Rolleston Pak'nSave Resource Consent Application

Outstanding Transportation Matters Response

Prepared for	Foodstuffs South Island Limited
Job Number	FSIL-J085
Revision	A
Issue Date	14 June 2022
Prepared by	Dave Smith, Technical Director
Reviewed by	Jay Baththana, Principal Transportation Engineer

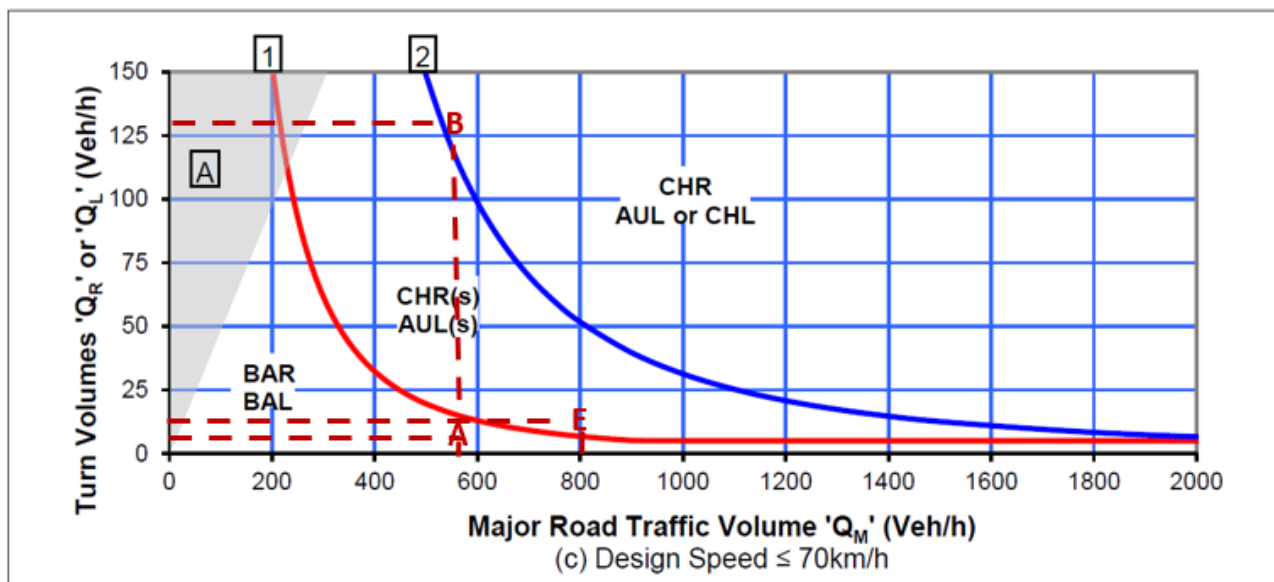
Please undertake an assessment to identify whether auxiliary turning lanes are required for vehicles turning left or right into the site at each access.

Matter not addressed

The warrant for an auxiliary left turn bay has been assessed. The modelled evening peak hour left turn volume is 7 vehicles and major road volume is 563. This is shown in the figure below by the red letter A and does not meet the volumes required for an auxiliary left turn lane.

Access B – There is no right turn into the site so the warrant for an auxiliary left turn bay has been assessed. The modelled peak hour left turn volume is 130 vehicles and major road volume is 570. This is shown in the figure below by the red letter B. The warrant is exceeded and a short left turn auxiliary lane is recommended to be included in detailed design for the access. It is confirmed that this can be accommodated within the road reserve as shown on the layout diagram below.

Access E - There is no right turn into the site so the warrant for an auxiliary left turn bay has been assessed. The modelled peak hour left turn volume is 14 and major road volume is 806. This is shown in the figure below by the letter E. The warrant is exceeded however noting that the speed environment is much lower than 70 kph and the access is predominantly for service vehicles (there is no signage encouraging use of this access), therefore there is low risk of adverse effects such that an auxiliary left turn lane is required. It is recommended that monitoring be undertaken to confirm that left turning vehicles are not impeding through vehicles during peak hour.

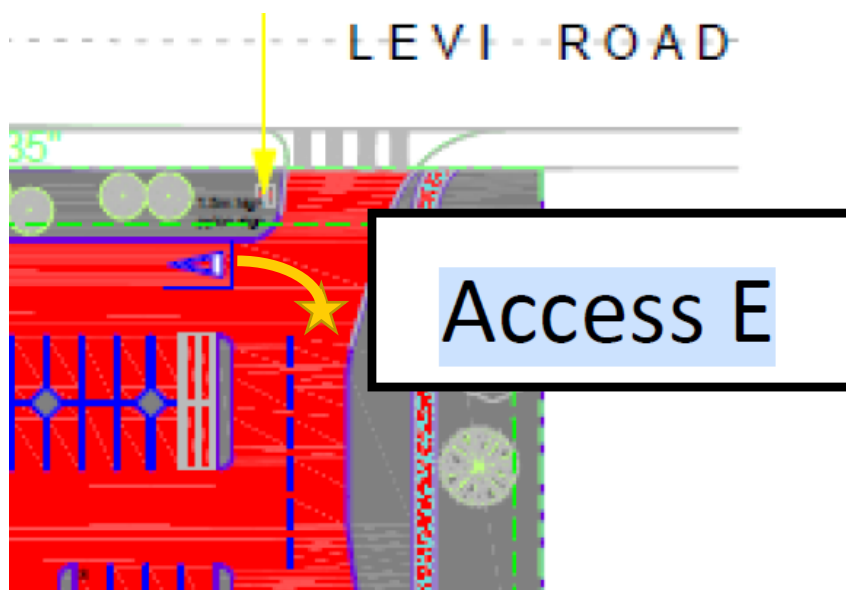
Rule E13.1.10.1 (Queuing Space) allows queuing space to be apportioned "in accordance with their potential usage". The calculation shown in the ITA simply divides the queuing space by the number of accesses and therefore has been applied incorrectly. Please revise the assessment of queuing space to take account of the usage of the accesses, as the wording of the Rule requires and comment on any non-compliance that arises.

Not addressed

The queuing distance requirement is met for the three highest volume accesses and is not applicable for access C as this is an exit only. Access E falls short of the minimum queueing distance requirement by 5 metres so is a technical non-compliance on the basis of the queuing space within the site.

In practical terms there are only a limited number of vehicle movements that are likely to occur in the vicinity of the access, and the first point of potential conflict is a vehicle turning right out of the northmost aisle as shown in the diagram below. Based on the likely vehicle path there is an effective queueing space in the order of 10 metres which matches the minimum requirement.

Furthermore, the right turners from the northmost aisle have a marked give way such that they must yield to incoming traffic reducing the likelihood of conflict at this location.

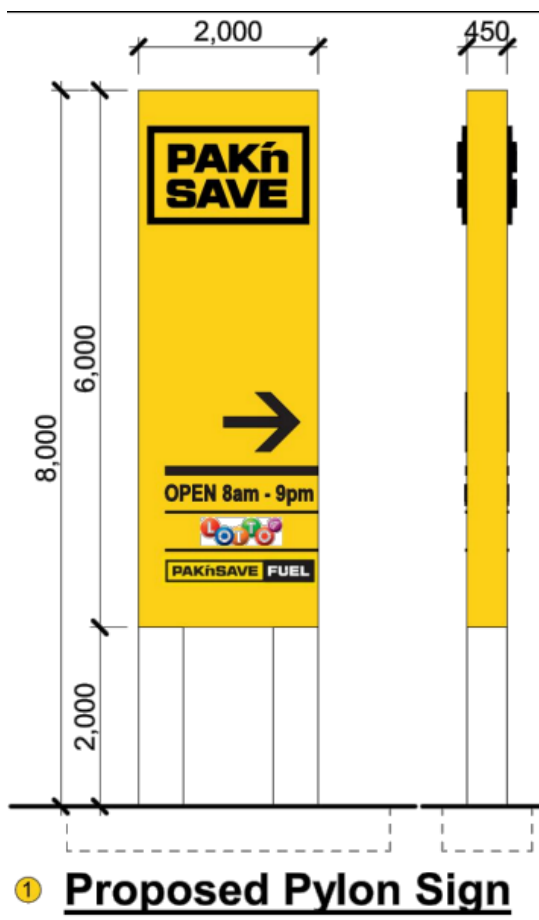
There appears to be signage to the immediate east of Access D. Please confirm that this does not adversely affect sight distances.

Query also related to vehicle sight distances - please provide these. There is also a matter arising - does this s92 response change as a result of the shared walking/cycling route now being moved onto the southern side of Levi Road?

The vehicle sight distance assessment based on *Guide to Road Design Part 4A: Unsignalised and Signalised Intersections* has been undertaken as follows. **Safe intersection sight distance (SSID)** - minimum sight distance which should be provided on the major road at any intersection (Main supermarket access treated as intersection) and **Minimum gap sight distance (MGSD)** for turning traffic based on a critical gap acceptance time of 5s (*Guide to Road Design Part 4A* Table 3.5, page 24) has been calculated.

Based on the existing speed limit of 50km/h (55 km/h operating speed environment) the SSID is 110 metres and the MGSD for a 60km/h operating speed is 83 metres (less for 55 km/h operating speed). The pylon sign slightly overlaps the SSID visibility triangle when measured from 5m from the edge line. However, it should be noted that the bottom two metres of the sign sits on stilts (see below) and does not fully impede intervisibility between vehicles at the access and on Levi Road. If SSID was measured at 3m (minimum set back) from the edge line the pylon sign will not impede visibility at all.

The assessment also demonstrates that the sight distance for left and right turning vehicles measured 3.5m from the edge line comfortably meets the MGSD requirement of 83 metres. Approach sight distance along the supermarket access has not been calculated given the obvious perception of the access intersection.

The assessment of pedestrian visibility remains unchanged with the shared walking/cycling route having been relocated of the south side of Levi Road corridor.
